Turbocharger Mounting Hardware Replacement

Section Function Group 255

Model Years	Models
2023-2024	VAH, VHD, VN

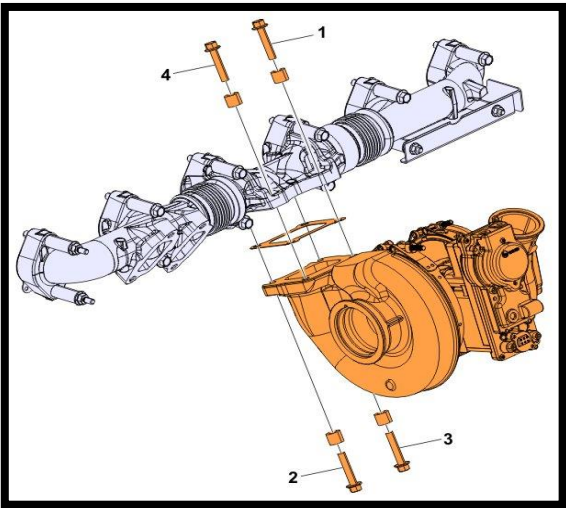
Turbocharger Mounting Hardware must be torqued following the sequence shown below.

Tightening torque		
Turbocharger, nut	1.	Tightening sequence: 1-4
		20 ±4 Nm (15 ±3 lb _r ·ft)
	2.	Tightening sequence: 1-4
		48 ±8 Nm (35 ±6 lb _r ·ft)
